REMEDIATION SYSTEM EVALUATION

DELPHI CORPORATION
VANDALIA, OHIO

Report of the Remediation System Evaluation,
Site Visit Conducted at the Delphi Corporation, Vandalia, Ohio Facility
March 6, 2003

EPA 542-F-04-023
June 2003
www.epa.gov/tio
clu-in.org/optimization

FIGURE 1-2. EXTENT OF DNAPL AND LOCATIONS OF DNAPL RECOVERY WELLS IN FIRST SAND UNIT OF OVERBURDEN

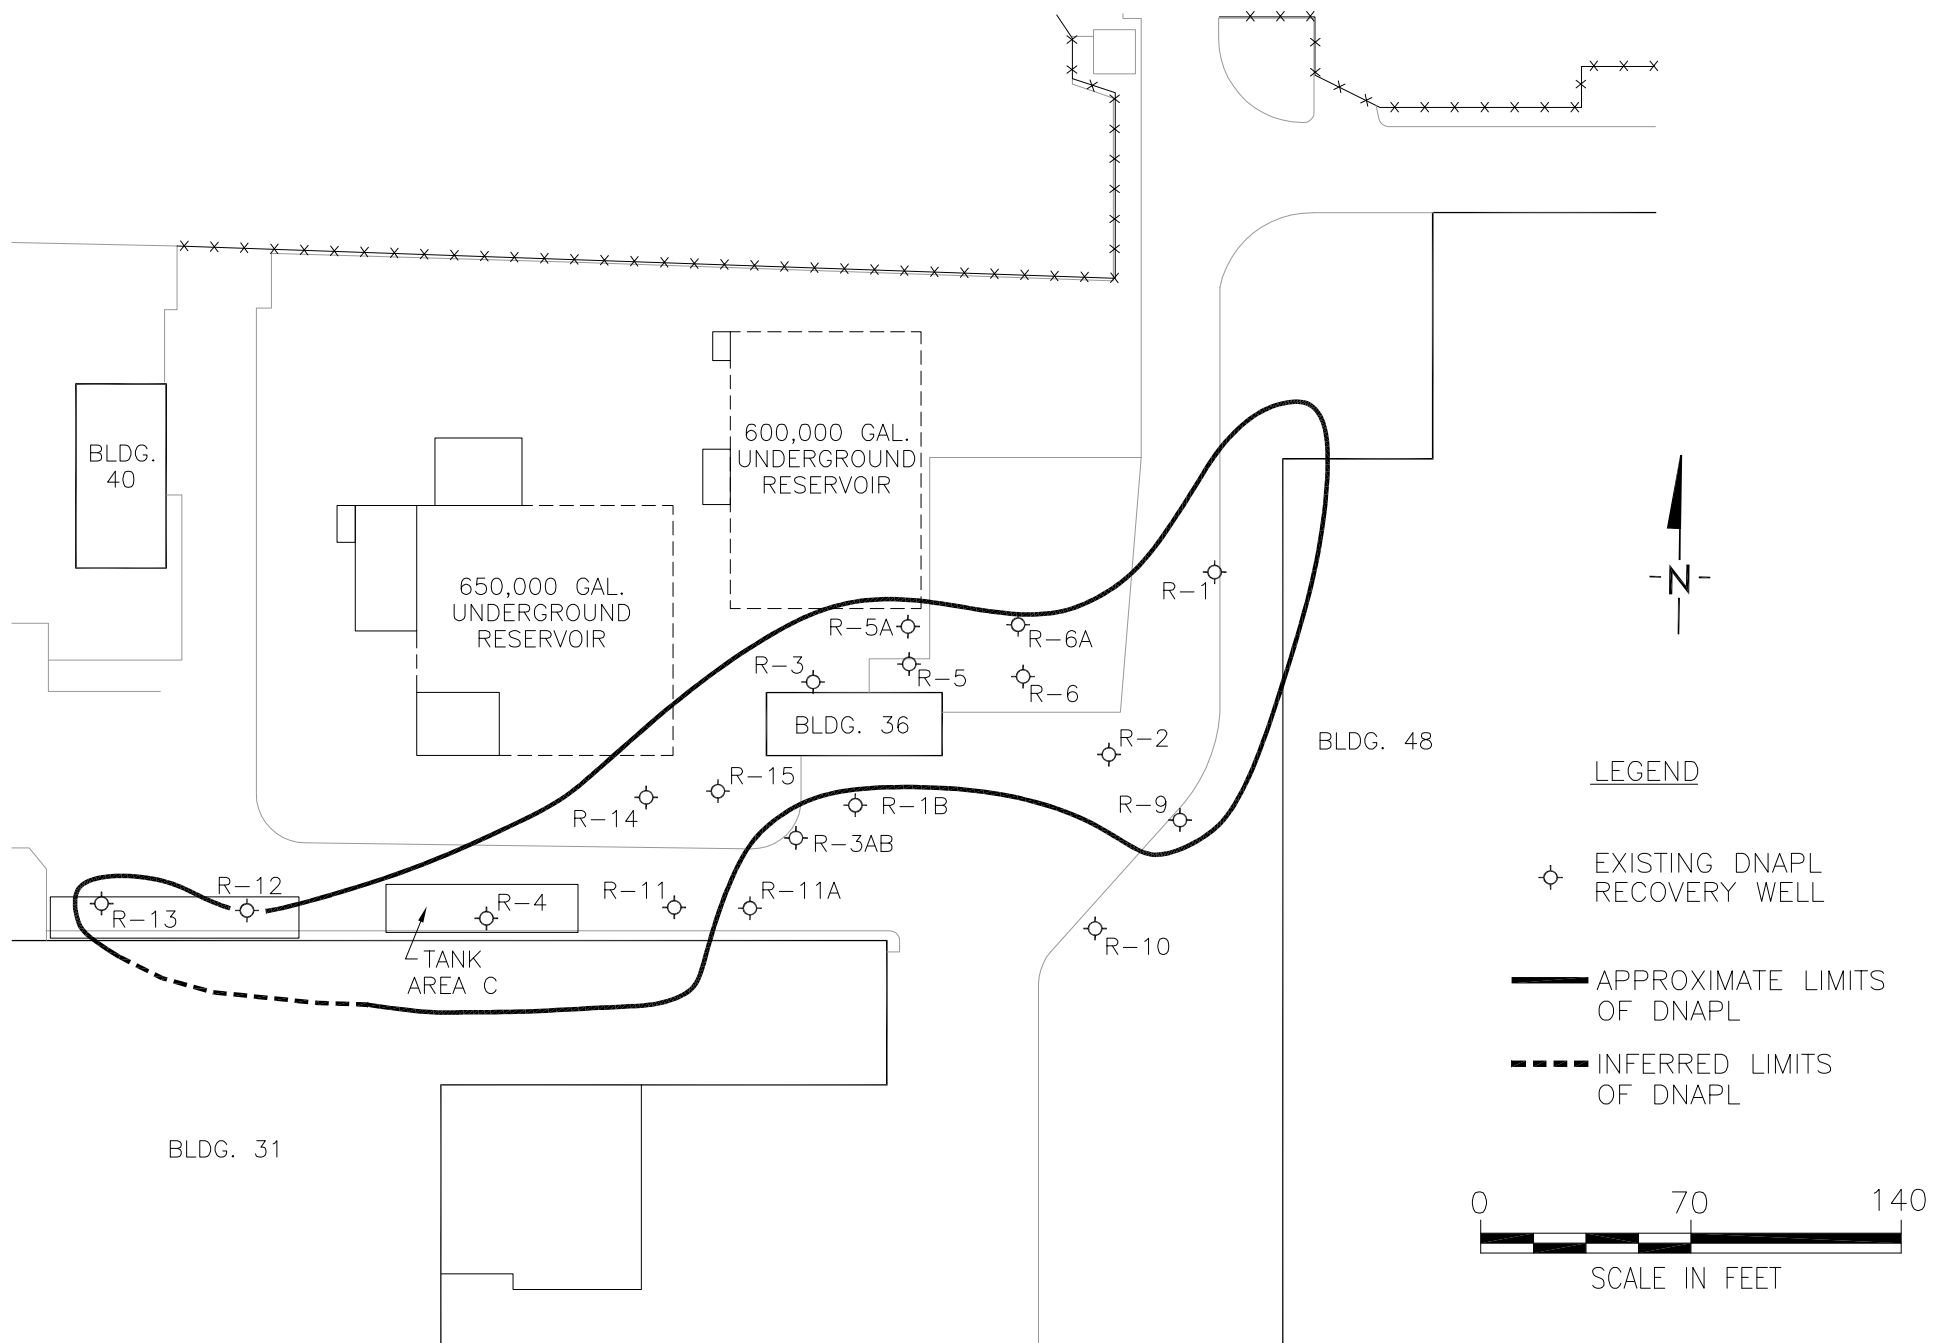
Thirteen 6-inch diameter stainless steel recovery wells are installed into the First Sand unit for DNAPL recovery (see Figure 1-2 for locations). A mobile extraction and treatment system operates seasonally from April to October and is typically employed at a well for 3 to 5 days then moved to one of the other 13 recovery wells. The DNAPL recovery system includes a QED Hammerhead pneumatic submersible pump, a Busch vacuum pump to vacuum enhance recovery, a phase separator, bag filter and 2 polymeric resin vessels in series. After treatment coproduced water is stored prior to discharge to the POTW. The system operates 40 hours per week with full time operator attention to visually inspect the system influent and make adjustments to the vacuum level and pumping rate.

FIGURE 1-3. TCE DISTRIBUTION IN THE TOP OF ROCK

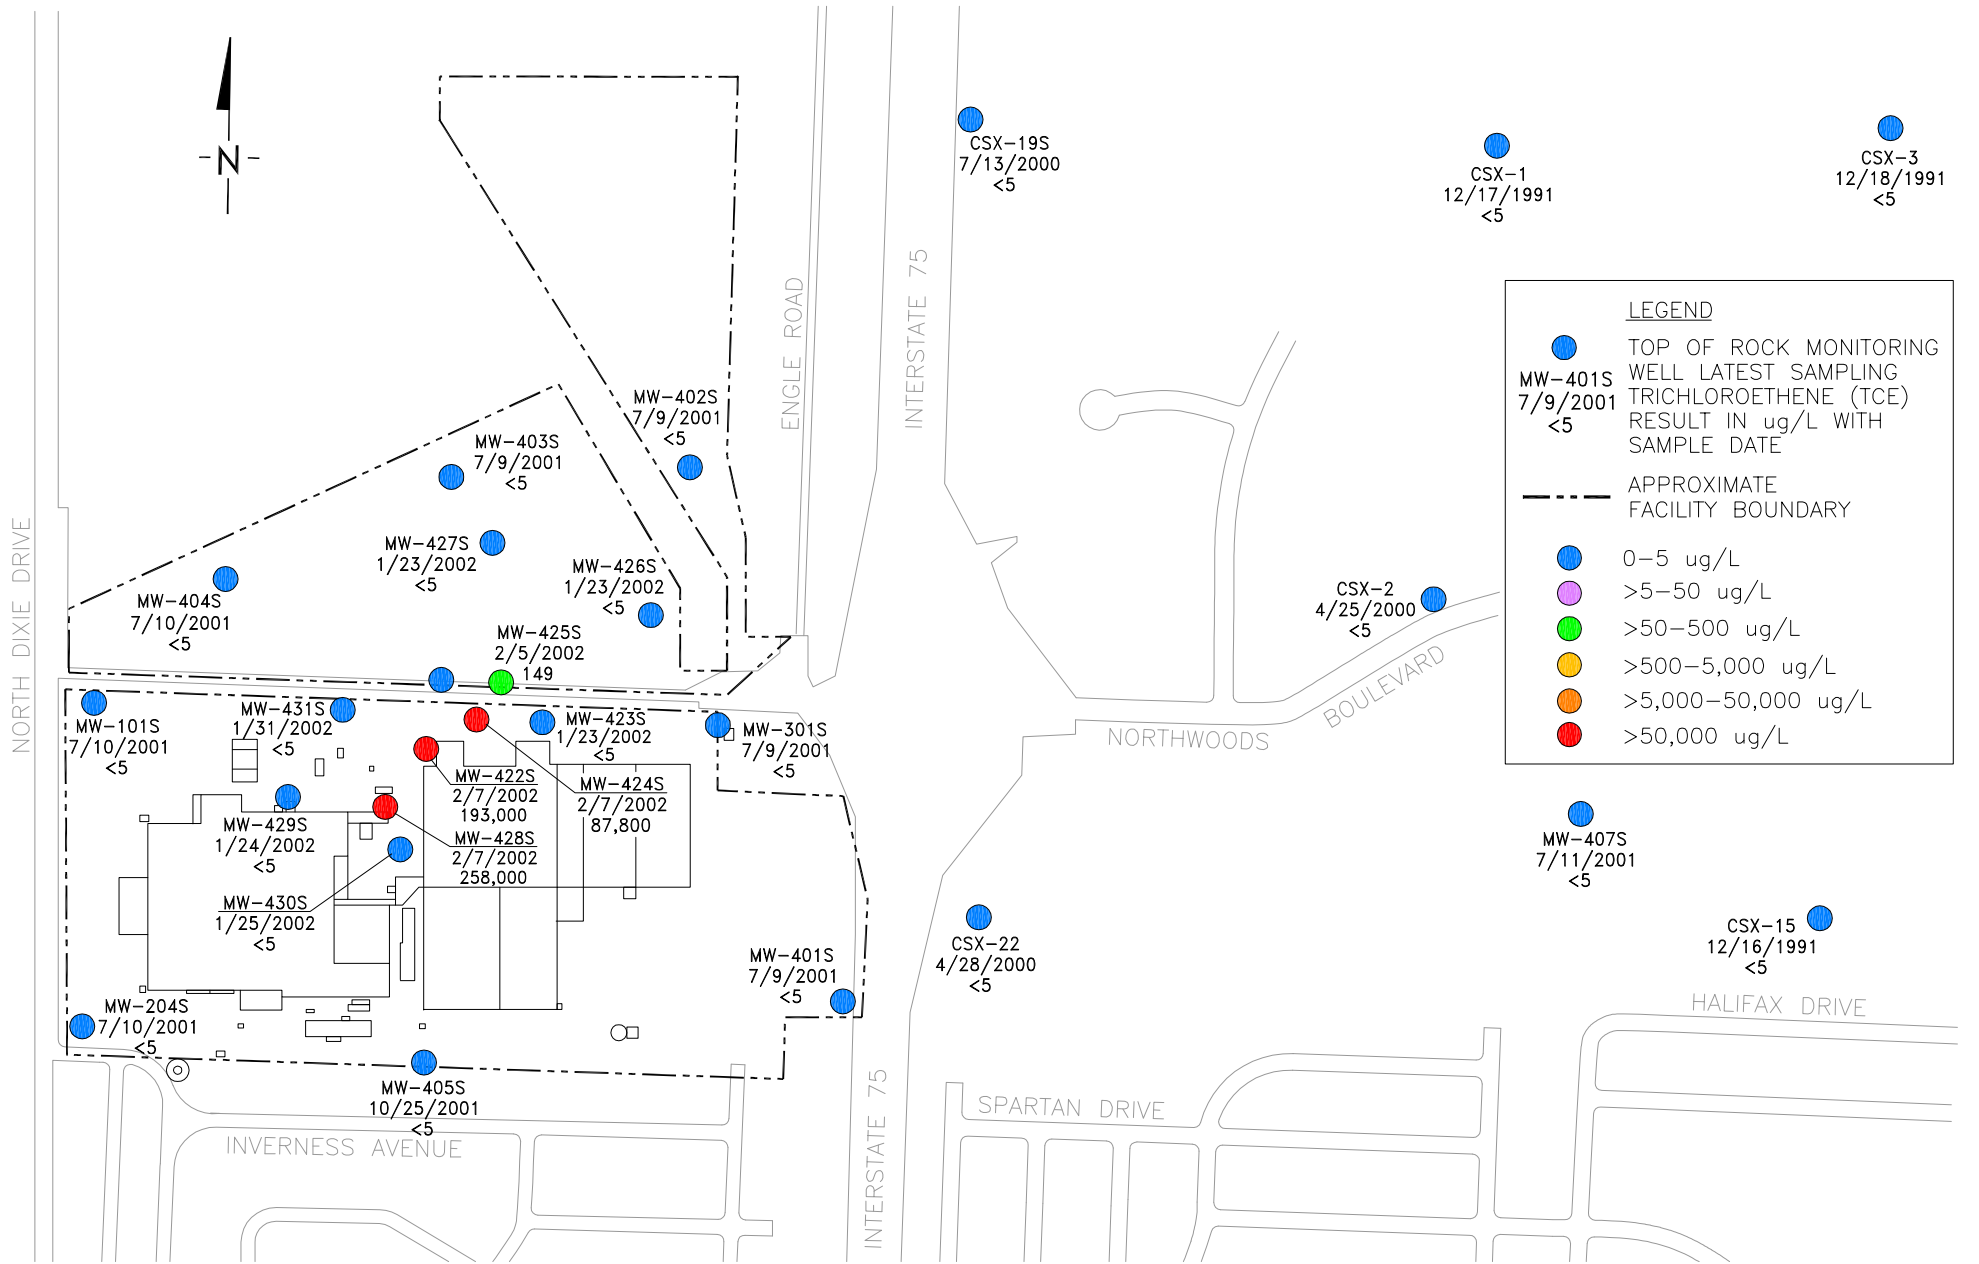
Dissolved ground water contamination in the Top of Rock zone (see Figure 1-3) appears to be controlled by a piezometric low near MW-424S (see Section 4.2.1 and 4.2.2 of this report) where water in the Top of Rock appears to discharge to the underlying Sugar Rock. Wells upgradient of this area historically have elevated TCE concentrations. For example, in the fourth quarter of 2002, MW-422S had a TCE concentration of 200,000 ug/L. Wells downgradient of this area (MW-423S, MW-445S, MW-446S, and others) have undetectable TCE concentrations. Although this piezometric low appears to capture site-related contamination within the Top of Rock aquifer, one supply well at a property located on Engle Road, located just north of the facility, has detectable concentrations of TCE that are below the MCLs. However, that well on Engle Road has an open intake that extends from the Top of Rock to the Sugar Rock, so the contamination at that well is likely drawn from the Sugar Rock.

In the Top of Rock, there is no intended target capture zone and no implemented remedy because contaminated water appears to be naturally contained by the discharge of water to the underlying Sugar Rock. As shown in Figure 1-3, ground water sampling and analysis in the Top of Rock suggests that VOC contamination above MCLs is limited to four wells in the north central portion of the property (MW-422S, MW-424S, MW-425S, and MW-428S). The sampling results from other monitoring wells in the Top of Rock and interpretation of capture from the potentiometric surface map suggest that the contamination in these wells is contained horizontally. The only indications of potential TCE or cis-1,2-DCE contamination in the Top of Rock that is likely outside of the capture zone are the sampling results from 10591 Engle Road, which is approximately 500 feet to the northeast of the facility and near the Unnamed Tributary. The concentrations at this location are below MCLs and all other wells in the area (both monitoring and supply wells) have no detectable concentrations of these constituents. This well is constructed with an open interval that extends from the Top of Rock to the Sugar Rock and it is likely that TCE in this well is related to the Sugar Rock.

FIGURE 1-4. TCE DISTRIBUTION IN THE SUGAR ROCK, FIRST QUARTER 2003

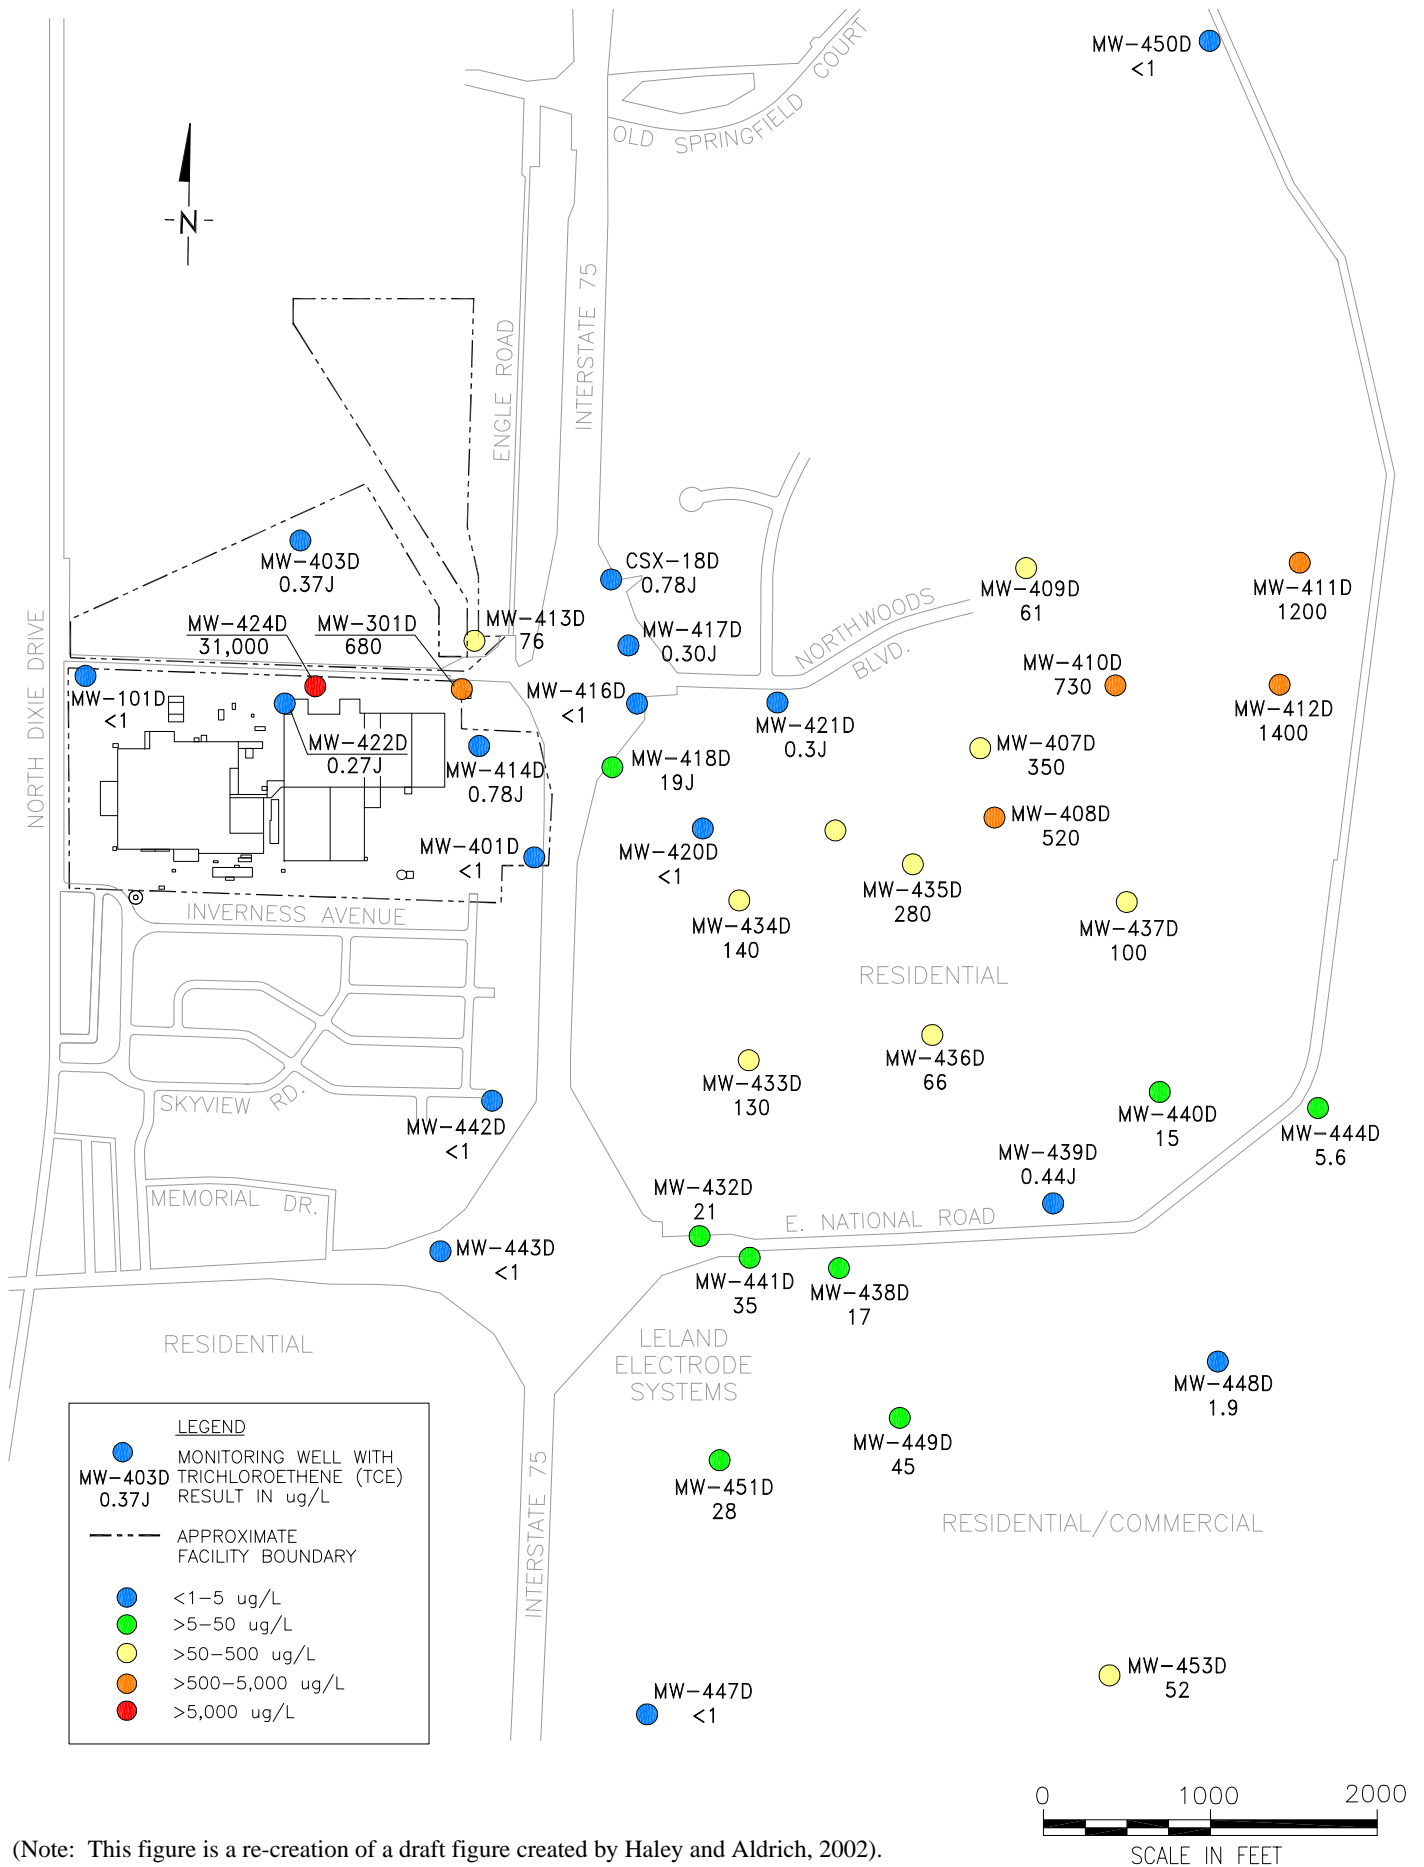
Ground water contamination in the Sugar Rock extends over a mile from the site to the east. The highest concentration in this unit is repeatedly detected at MW-424D (see Figure 1-4 for location), which is located in the area where TCE impacted water from the Top of Rock zone is suspected to enter the Sugar Rock through an old production well boring. During the fourth quarter of 2002, MW-424D had a TCE concentration of 30,000 ug/L. Elevated concentrations of cis-1,2-DCE and 1,1 DCA were also detected (5,000 ug/L cis-1,2-DCE and 290 ug/L 1,1 DCA). Concentrations offsite to the east decrease near P-301, which is the extraction well for the ground water migration control system, and then increase again approximately 3,000 feet from the facility. In the first quarter of 2003, the TCE concentrations along Cassel Road were over 1,000 ug/L (1,200 ug/L in MW-411D and 1,400 ug/L in MW-412D). Beyond these points ground water discharge through seeps to surface water that eventually empties into the Great Miami River.

FIGURE 4-1. POTENTIOMETRIC SURFACE MAP FOR THE TOP OF ROCK, JULY 2002

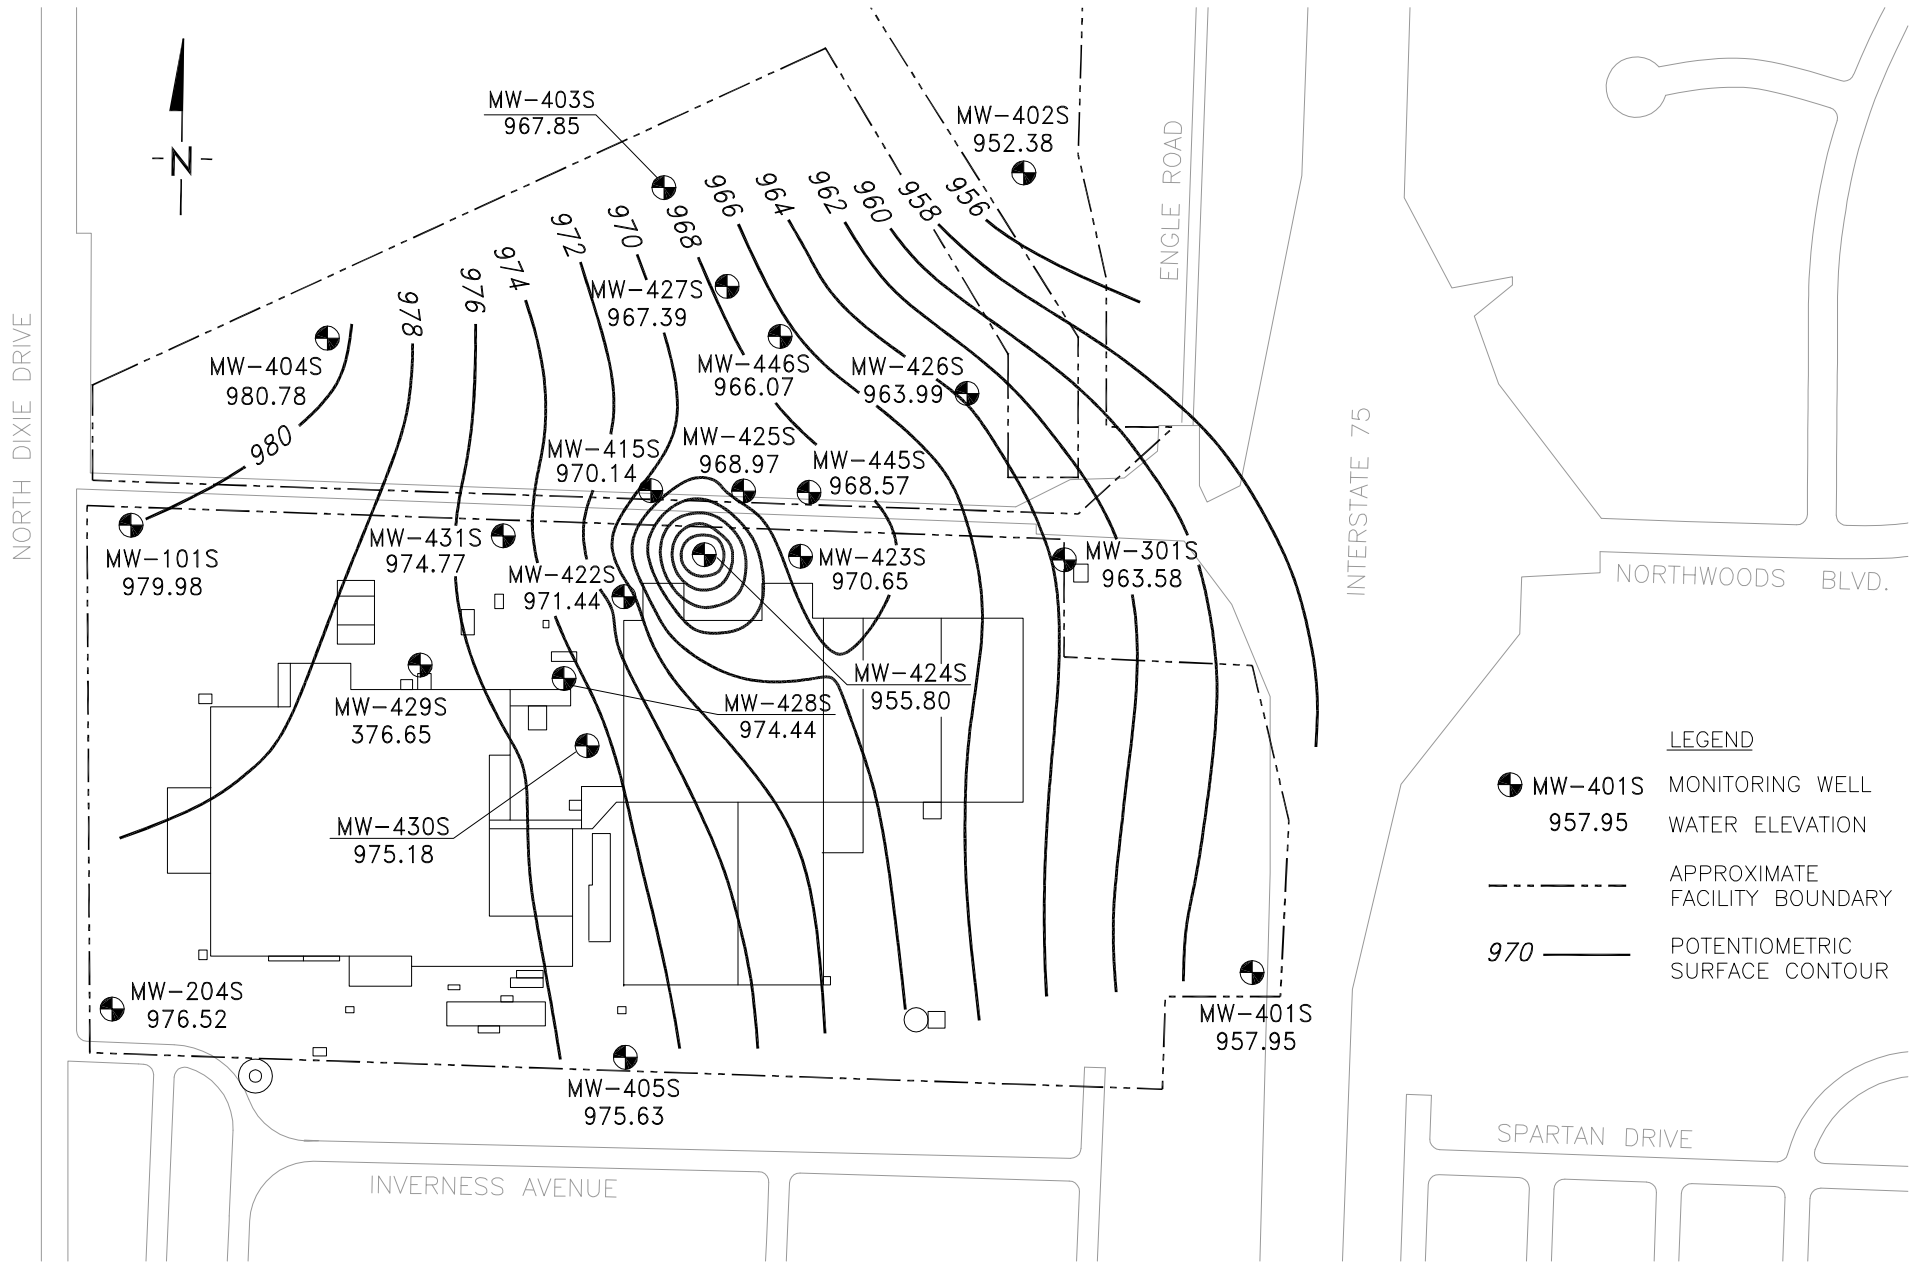
Water levels from the Top of Rock are collected quarterly and corresponding potentiometric maps are generated. Figures 4-1 depicts a typical potentiometric surface map for the Top of Rock unit. The regional water elevation ranges from approximately 980 feet above mean sea level (MSL) at the western property boundary to approximately 960 feet MSL at the eastern property boundary. A localized low in the water table is present at MW-424S where the water level is approximately 956 feet MSL. This low likely represents an area where water from the Top of Rock discharges to the Sugar Rock.
